ADDENDUM NO. 6
TO GENERAL, MECHANICAL AND ELECTRICAL
ABERDEEN PUBLIC WORKS
MAINTENANCE BUILDING
ABERDEEN, SOUTH DAKOTA

Addendum Dated: March 27, 2026

Original Plans and Specifications Dated: February 20, 2026

1 FIRST FLOOR LIGHTING PLAN - AREA D
1/8" = 1'-0"

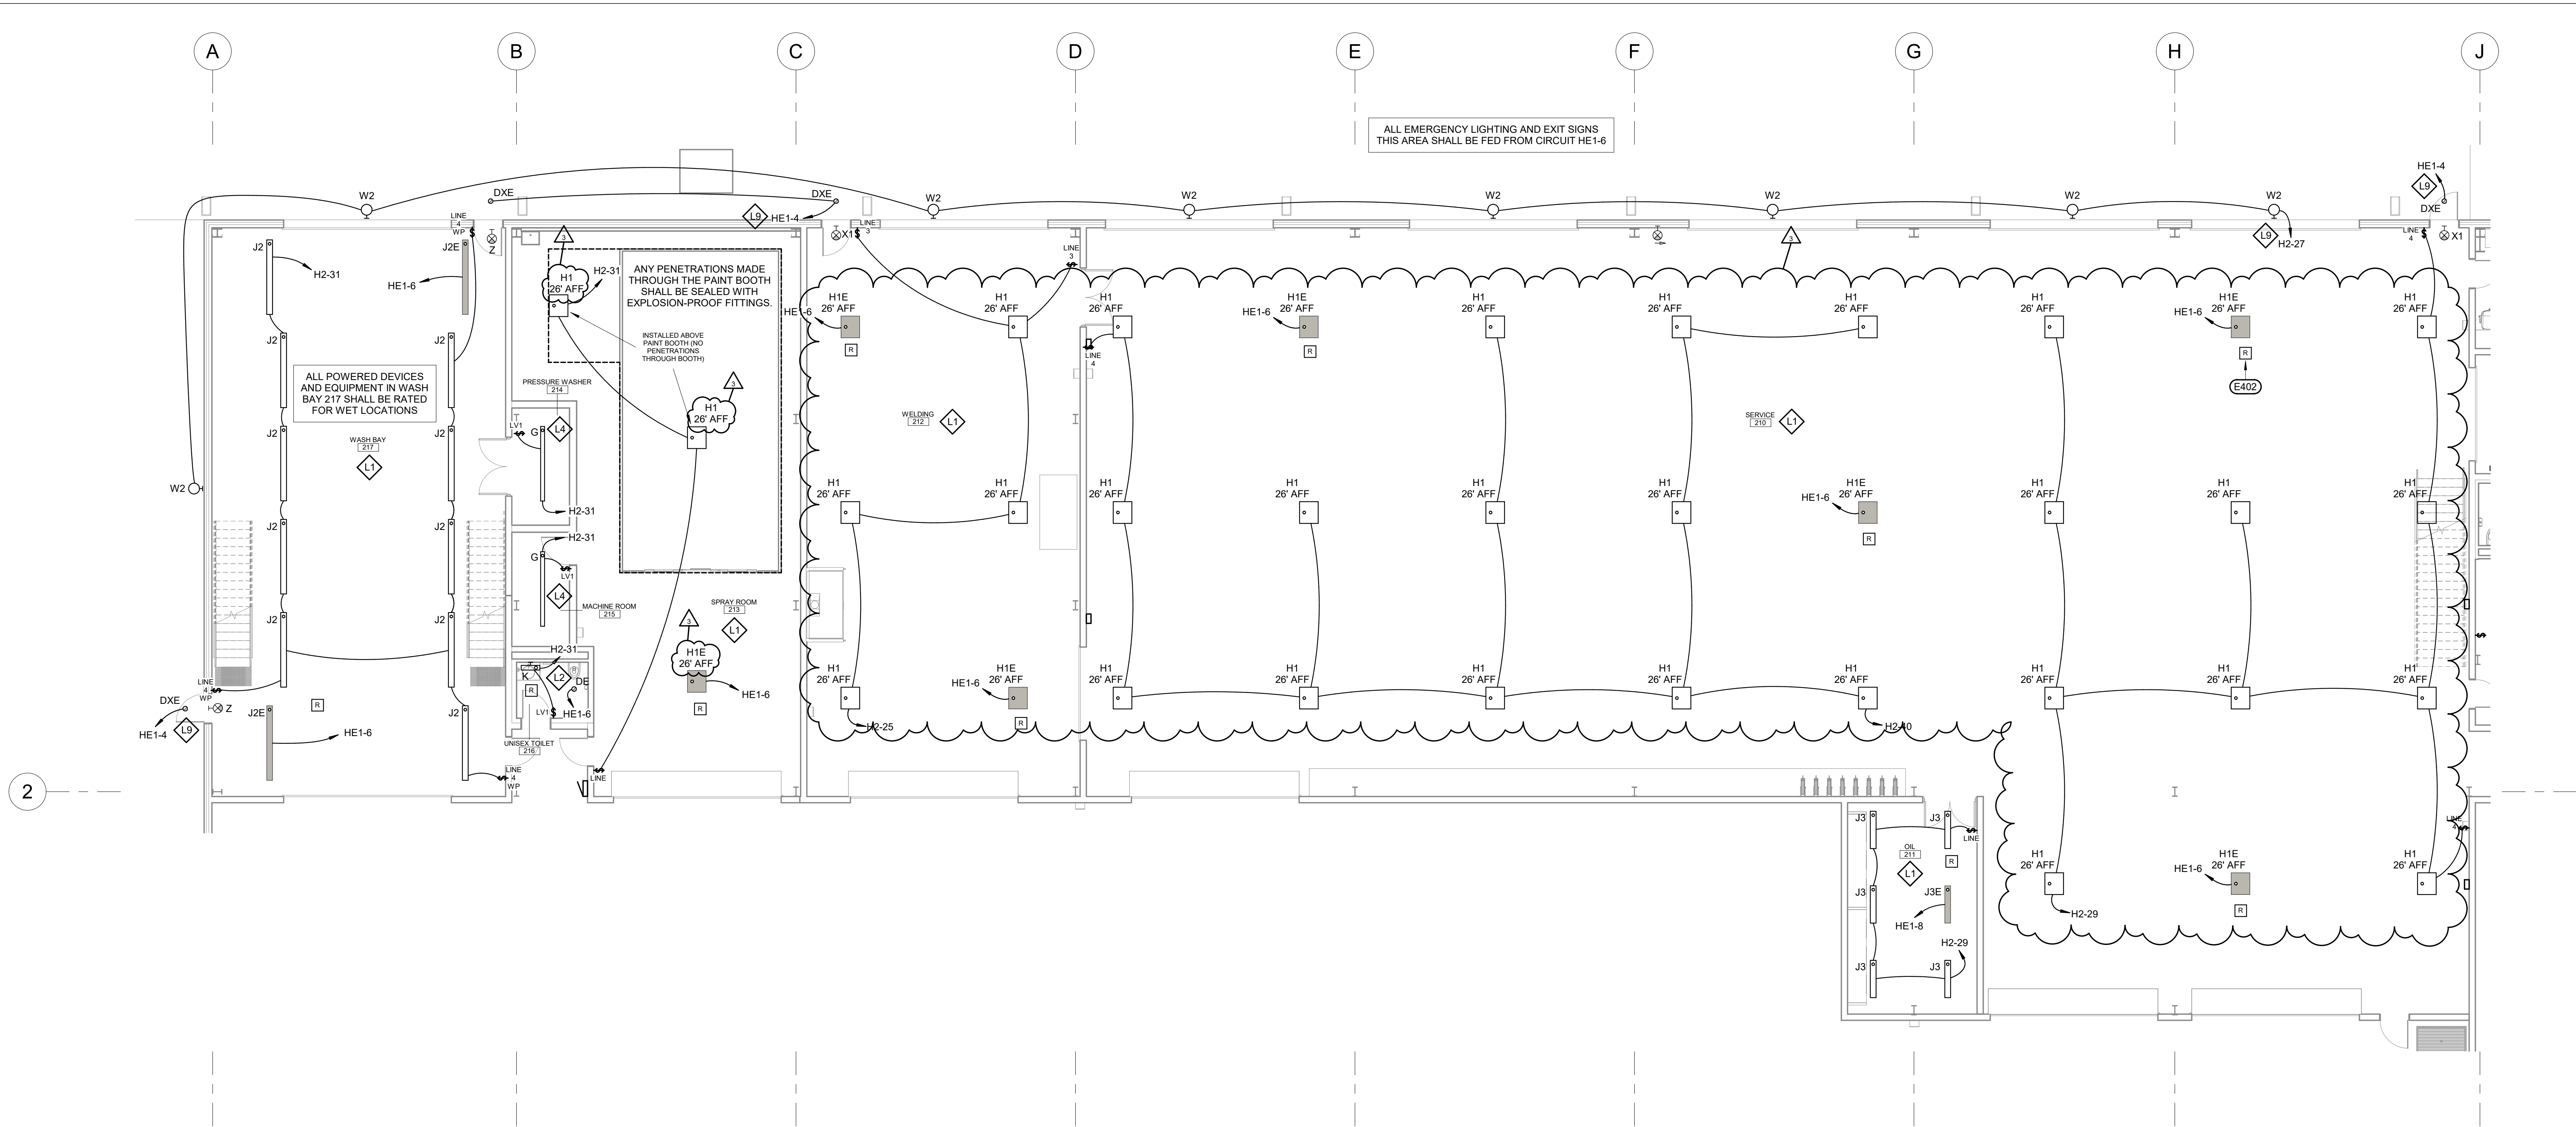
1. See attached sheet for the following revisions:
 - a. Clarified fixture heights for all Type H1/H1E fixtures.

1 MEZZANINE FLOOR LIGHTING PLAN - AREA A
1/8" = 1'-0"

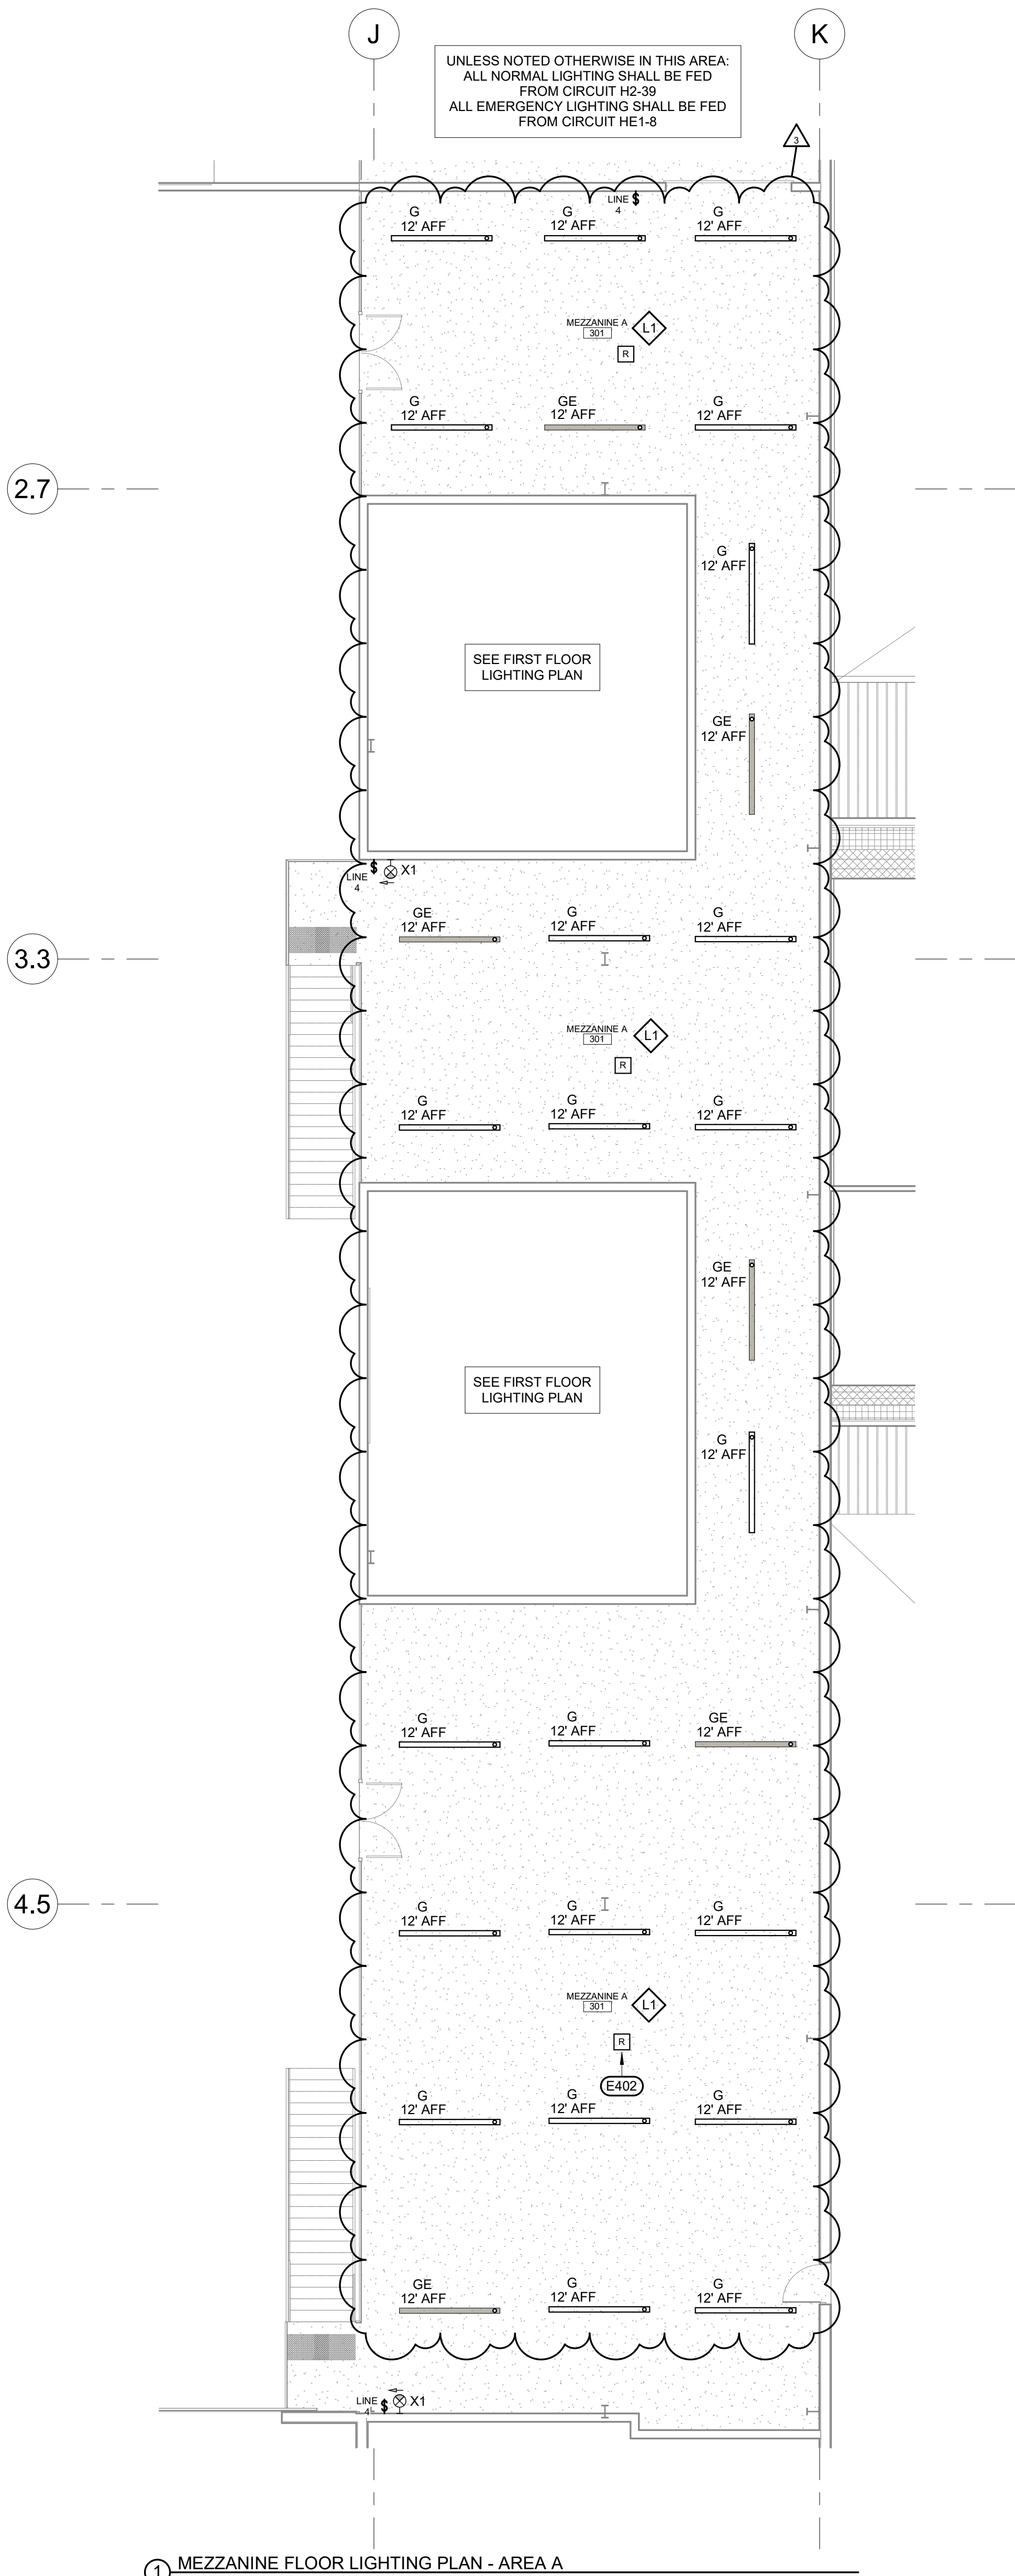
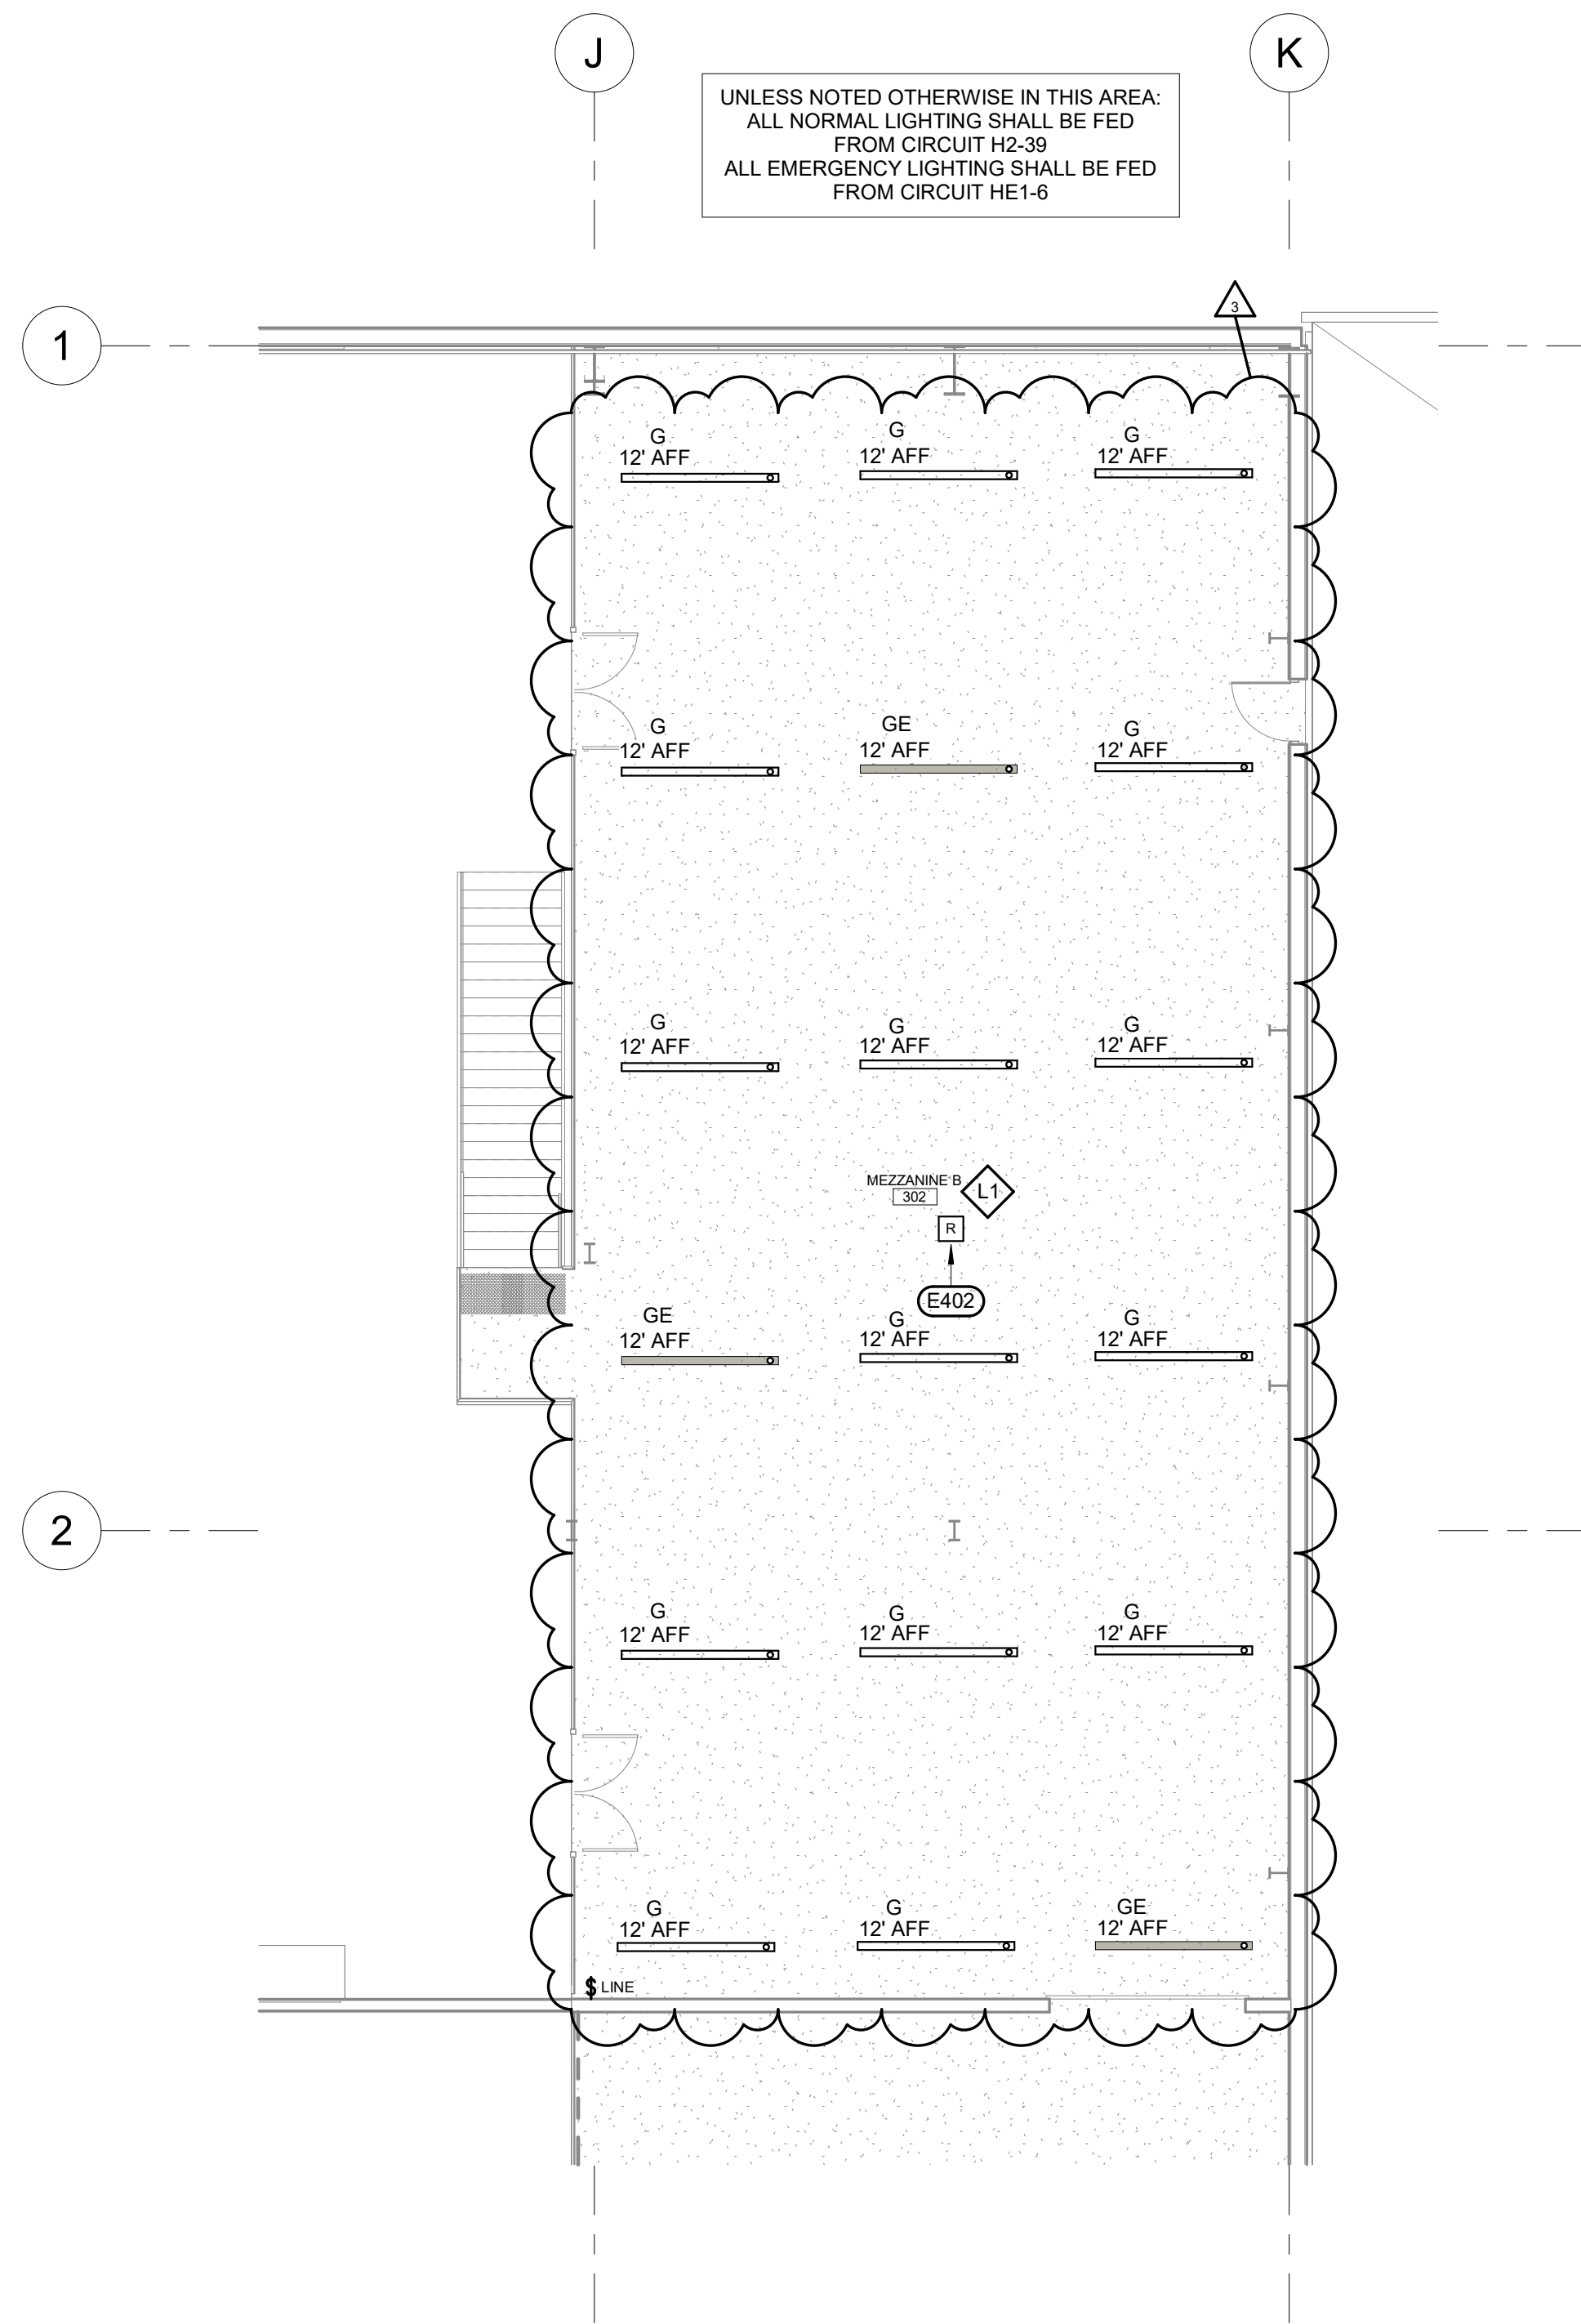
1. See attached sheet for the following revisions:
 - a. Clarified fixture heights for all Type G/GE fixtures.
